FINAL REPORT

With comments and remarks by ex-
perts of claimants

requested by judgment of the 8th of July 2015
issued by the HAGUE DISTRICT COURT
(Chamber of Commercial Affairs)

Accident occurring in FARO Airport – Portugal
21st of December 1992

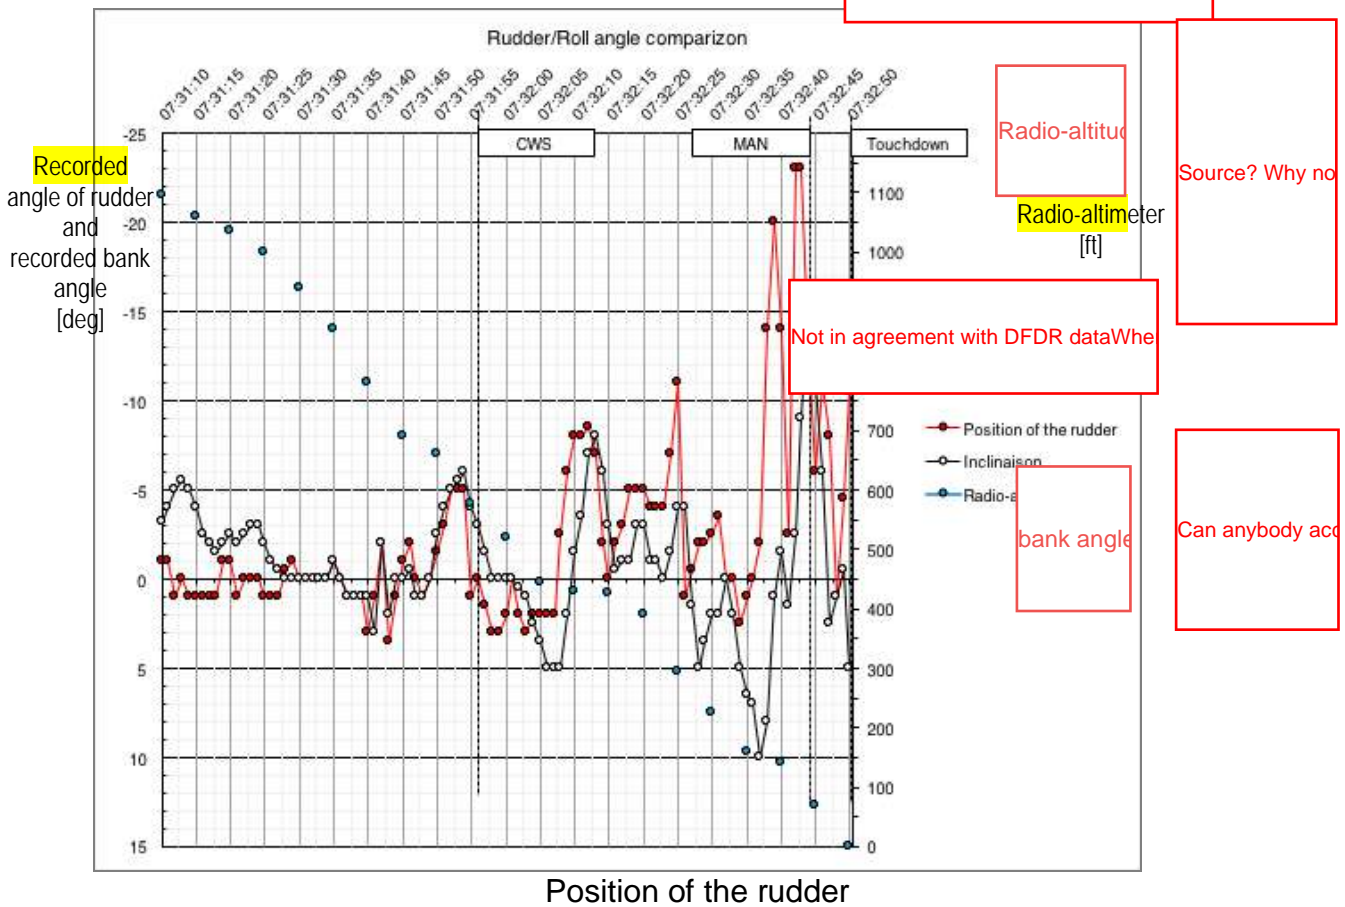
there was light turbulence

What is your conclusion?

Did they mention this exact time? What about DFDR data? These

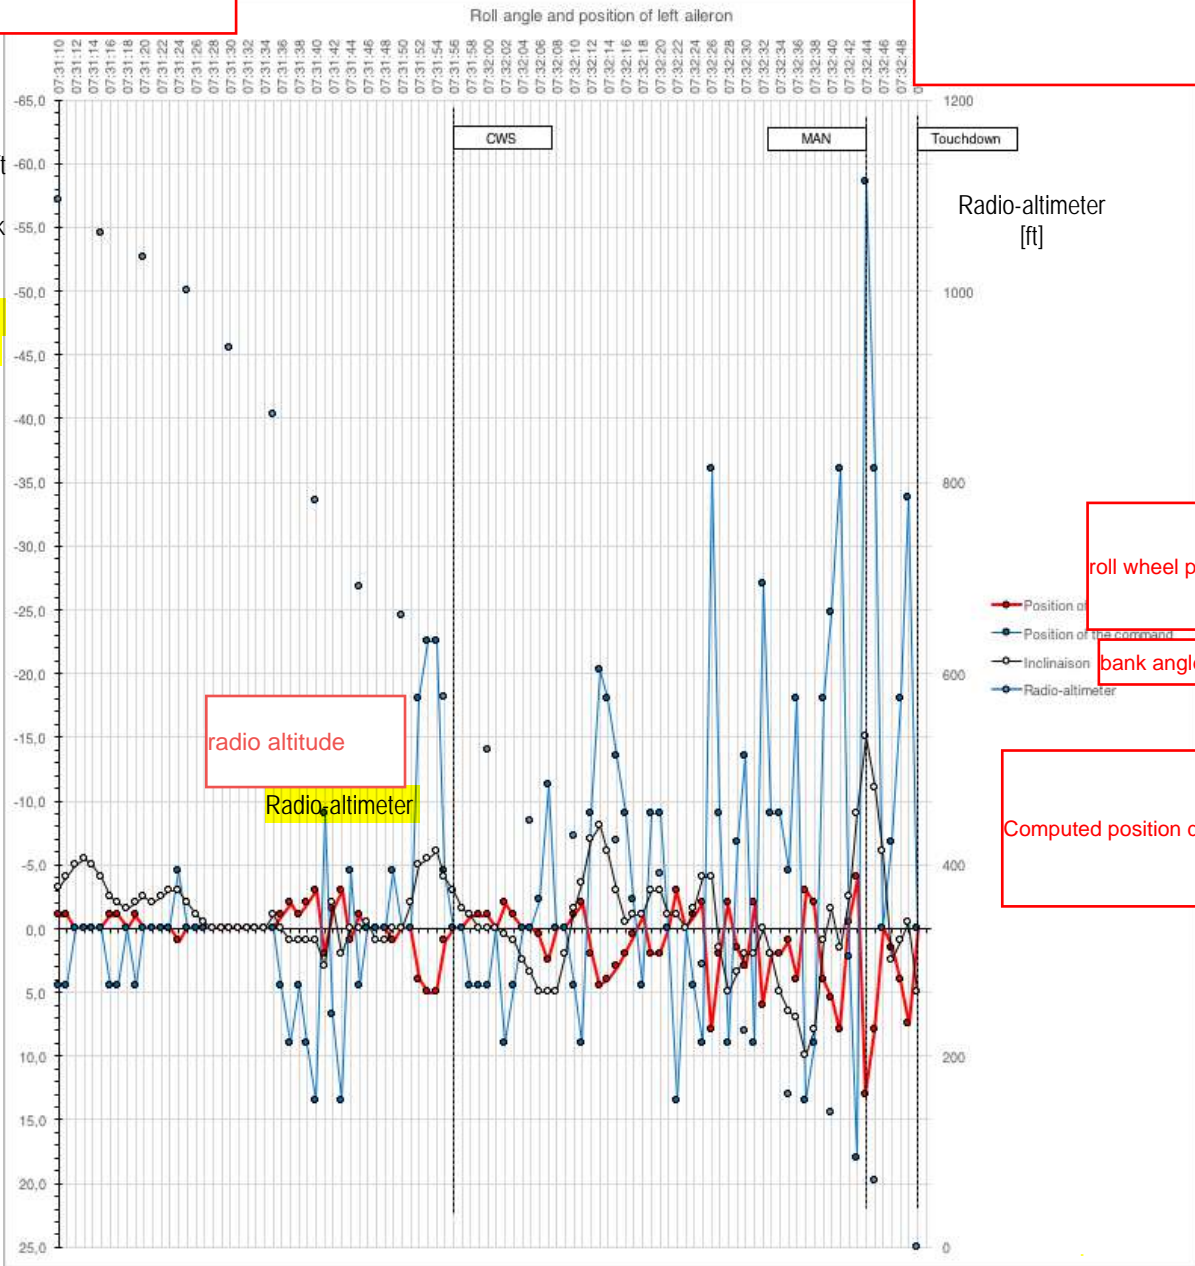
relevant?

control wheel is > certain threshold (5 units)
